Access Compliance Report

Public Rights-of-Way (Curb Ramps)

Intersection ID: 29956	Main Street: NEW_HOUSE_DR	Cross Street: ROYAL_BLUFF_DR	Location: NW
ADA ID: 5577B52E247D	Ramp Type: PerpDiag	Initial Pass/Fail: Fail	Overall Compliance: No Severity Score: 21.25

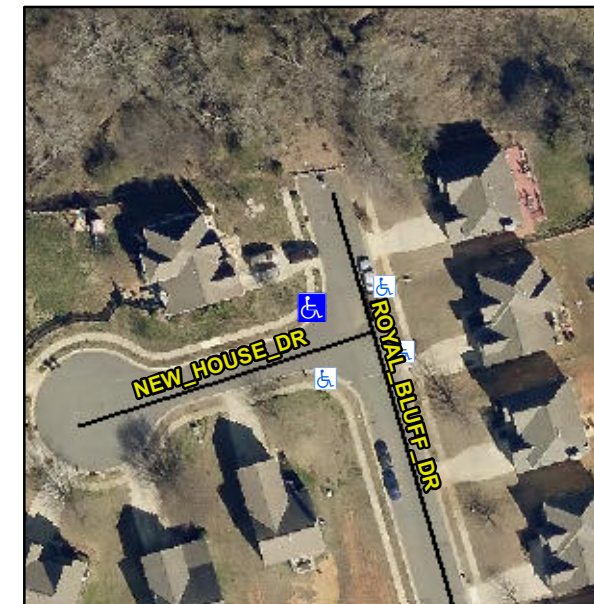
R304.5.1, R304.2.2

Compliance	Description	Data	Compliance	Description	Data
N/A	Ramp Length (in)	47.5	No	Ramp Slope (%)	9.5
No	Ramp Width (in)	41.0	Yes	Ramp XSlope (%)	0.9
N/A	Flare Type LT	N/A	N/A	Flare Type RT	N/A
N/A	Flare Slope LT (%)	N/A	N/A	Flare Slope RT (%)	N/A
N/A	Flare Traversable LT?	N/A	N/A	Flare Traversable RT?	N/A
N/A	Landing Length (in)	N/A	N/A	DWS Provided?	N/A
N/A	Landing Width (in)	N/A	N/A	DWS Contrast?	N/A
N/A	Landing Slope (%)	N/A	N/A	DWS Length (in)	N/A
N/A	Landing X Slope (%)	N/A	N/A	DWS Full Width?	N/A
N/A	Landing Curb? (Y/N)	N/A	N/A	DWS Offset (in)	N/A
N/A	Shared Landing?	N/A			
N/A	Gutter Ponding?	N/A	N/A	Gutter Slope (%)	N/A
N/A	Gutter Lip Ht (in)	N/A	N/A	Gutter X Slope (%)	N/A
N/A	Painted X Walk1?	No	N/A	Painted X Walk2?	No
	X Walk 1 Direction	To S		X Walk 2 Direction	To E
N/A	X Walk 1 Width (in)	N/A	N/A	X Walk 2 Width (in)	N/A
	X Walk 1 Slope (%)	3.0		X Walk 2 Slope (%)	4.0
	X Walk 1 X Slope (%)	4.8		X Walk 2 X Slope (%)	1.9

Remove & Replace Curb Ramp With Two New Directional Ramps or Equivalent.
